POWER PLANT - DRAINS TUBES AND MAST - RESET OIL SCUPPER DRAINS TUBE AND MODIFIED
SUPPORT BRACKETS AT CLIPPING POINT 2607 - CATEGORY CODE 7 - MOD.ENG-71-0151

V2500-ENG-71-0151

Location of Tube assembly and support bracket
fig.1

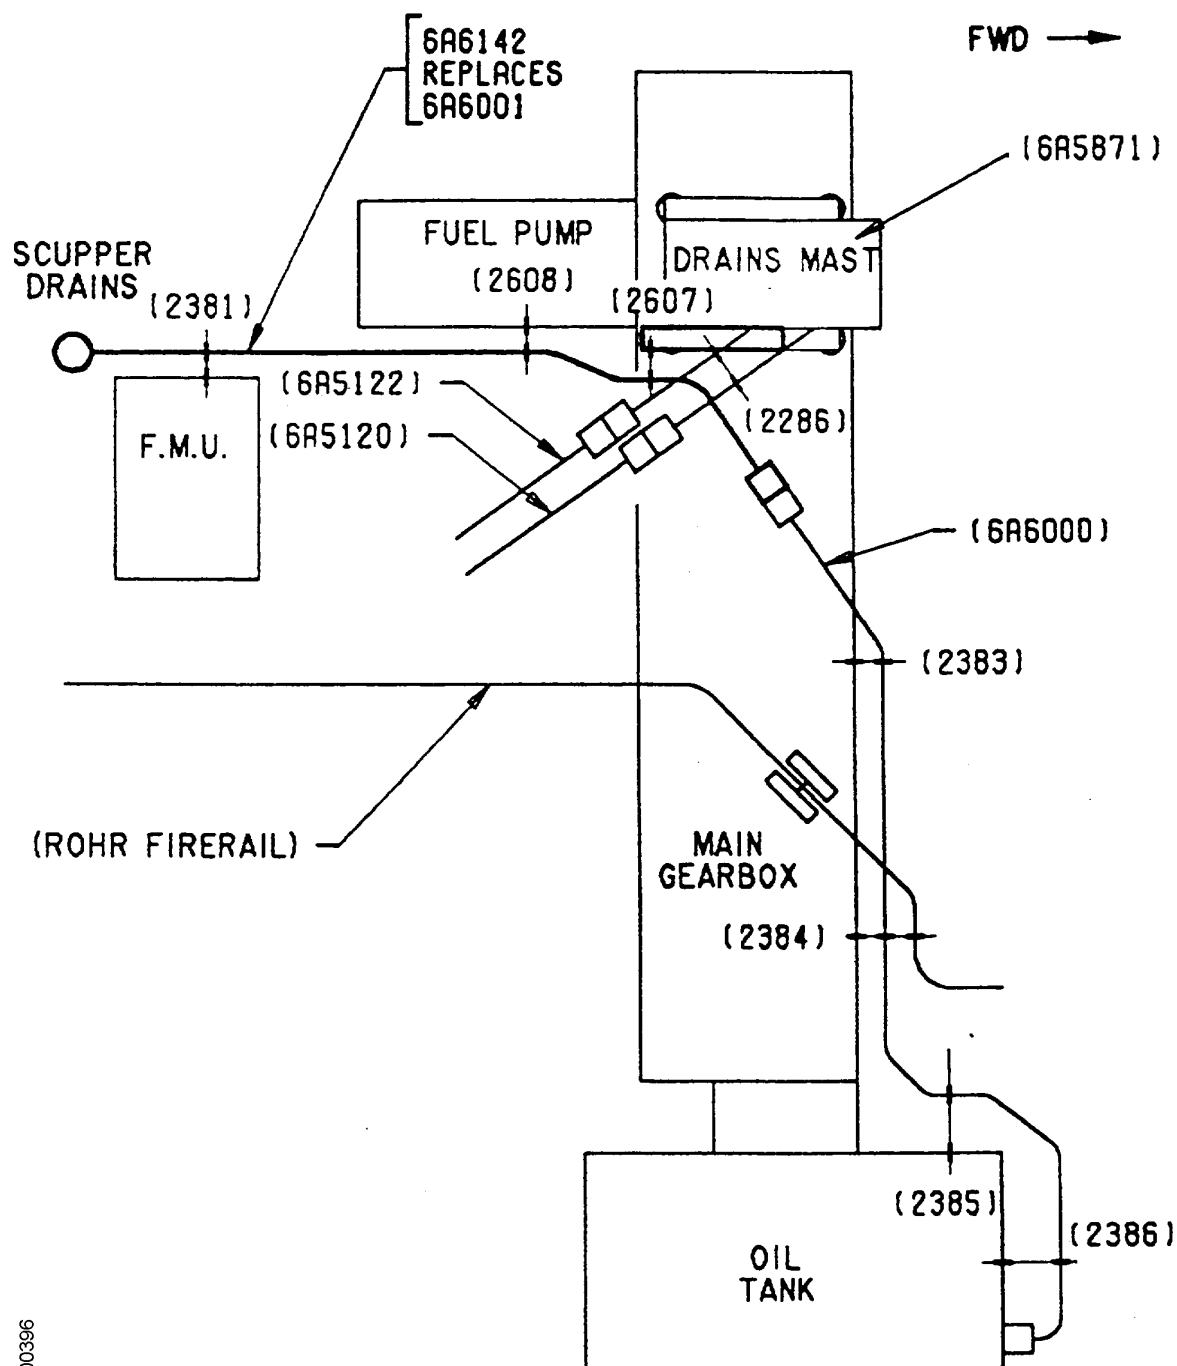
- (1) Find the clipping points CP2381, CP2608 and CP2607. Refer to Figures 1 and 2.
- (2) Disassemble the clipping points sufficiently to allow removal of 6A6001 tube.

Schematic view of scupper drains tubes - Before and after alteration
fig.2

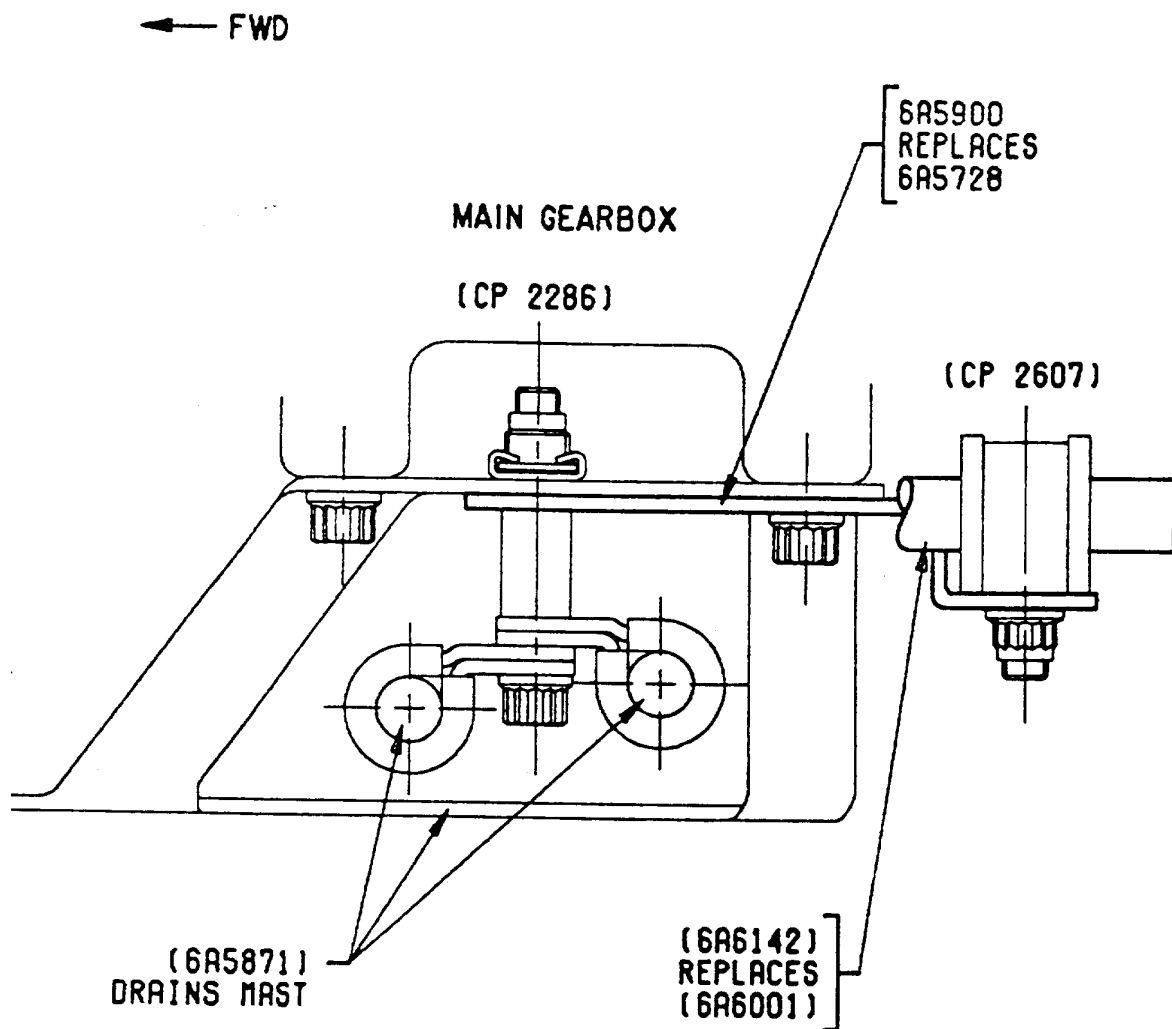
A foul may occur between the oil scupper drains tube outlet and the fan cowl vent louvres, also between the tube and the support bracket at CP2607.

- (a) A new tube assembly reset locally at the location of fan cowl vent louvres.
- (b) A new bracket with an altered profile ensuring improved clearance between the bracket and the scupper drain tube.

- (9) Install the new 6A6142 tube, connect to 6A6000 tube and torque to 230 to 248 lbfin (26 to 28 Nm). Refer to Figure 2.
- (10) Safety the new 6A6142 tube connector with CoMat 02-126 lockwire.
